TECHNICAL BULLETIN — June 2016

403. Hoerbiger hydraulic cylinders

Issuing Entity:	Bulletin No.: SB-033_02
Vekoma Rides Parts & Services B.V.	Release Date: 16-03-2016
Schaapweg 18	Effective Date: immediately
6063 BA VLODROP	Supersedes: SB-033_01
The Netherlands	Completion Date: 01-01-2017
CoC Number: 12049585

Service Bulletin

Figure 2: how to apply torque striping on the threaded screw assembly at the bottom.

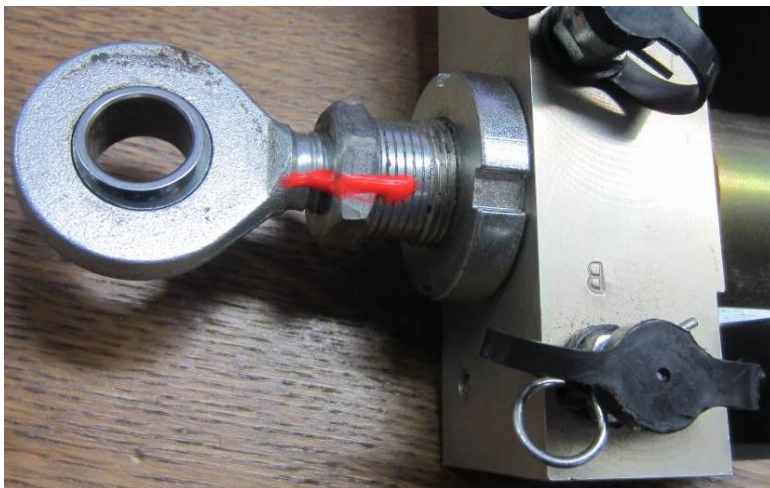
- Issue** : The supplier added an additional requirement on the length of the threaded screw assembly. Due to the adjustment function of this connection it is not guaranteed that the threaded screw assembly is within the specified range.
- Action VRP&S'** : Checking this connection was included during installation of the HLU in the vehicle.
- VRP&S' advice** : Check the length of the threaded screw assembly. If applicable it needs to be corrected. For the correct settings, please refer to the text below for the LE32 units and table 2 for the LE25 units (these values are created from the Supplier's document). Add torque striping to the connection (see figure 2) and perform a weekly check on this area.

Figure 3: information for LE32 and LE25 screw connection at the bottom.

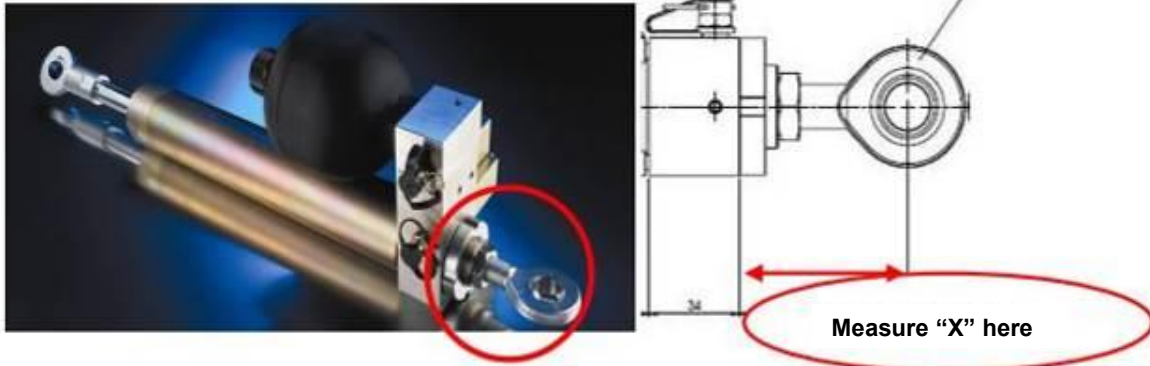
The following data apply for all LE32 versions:

For the LE 32 versions the screw thread depth is correct when the rod end length “X” is below 65 mm. ($X < 65\text{mm}$)

The following data apply for all LE25 versions:

For the LE 25 versions the screw thread depth is correct if the rod end length “X” is below the value as stated behind the product number in de table below. The small x at the end of the product number indicates the version number.

We recommend that the joint rod heads be secured at the specified dimensions and tightened with a torque wrench. The LE 25 version should be tightened to **80 Nm ±10 Nm**. The LE 32 version should be tightened to **90 Nm ±10 Nm**.

The correct measurement must be set and checked when installing or performing maintenance on the Cylinder Accumulator unit. In this way the required minimum screw thread depth engagement (as set out in VDI 2230) is maintained.

This example image is for reference of dimension X only.

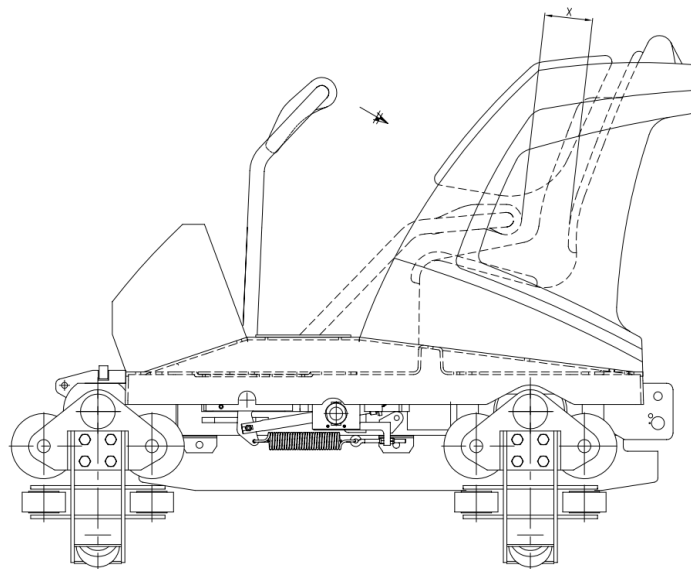
The cycle test is a test which provides information about the functionality of the HLU and the scale of the contaminations. The cycles test has to be performed 1050 times. After completion of 200 cycles succesfully, the ride can be taken into operation with passengers.

1. Close the restraint, make sure the right hand side HLU is only locking the restraint;
2. Measure the minimal distance (X) between the restraint and the seat (only at start of test);
3. Log this dimension for every seat (only at start of the test);
4. Wait for 10 seconds;
5. Measure the minimal distance (X) between the restraint and the seat;
6. In case this dimension increased by 2 cm the HLU failed and needs to be replaced immediately by a HLU which passed the 1050 cycles;
7. If no dimension change was noticed proceed with step 1;
8. Keep repeating this procedure until 200 cycles have passed the test procedure;
9. Repeat this test and make sure the left hand side HLU is only locking the restraint;
10. After completion of the 200 cycle test for the left and the right HLU it is allowed to take the vehicle in operation.

1. Close the restraint
2. Measure the minimal distance (X) between the restraint and the seat (only at start of test);
3. Log this dimension for every seat (only at start of the test);
4. Wait for 10 seconds;
5. Measure the minimal distance (X) between the restraint and the seat;
6. In case this dimension increased by 2 cm the HLU failed and needs to be replaced immediately by a HLU which passed the 1050 cycles;
7. If no dimension change was noticed proceed with step 1;
8. Keep repeating this procedure until 200 cycles have passed the test procedure;
9. After completion of the 200 cycle test for the single HLU it is allowed to take the vehicle in operation.

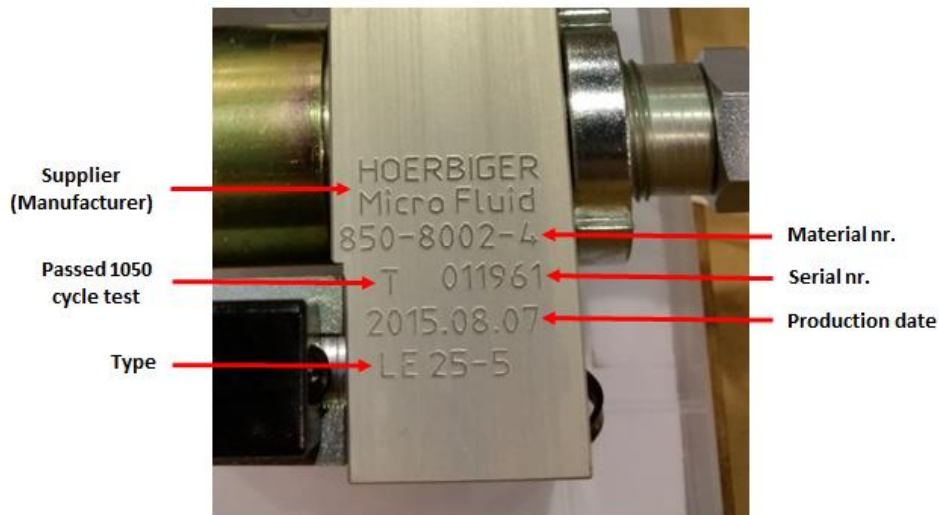
Hoerbiger has released an official statement regarding the lifetime of the HLU's (LE systems). Starting from delivery, LE systems must be replaced with new LE systems within **7 years**.

The two figures below explain the engraved data and the sticker data on the HLU's. All HLU's manufactured before June 2015 are equipped with a sticker and all HLU's manufactured from June 2015 and beyond are engraved.
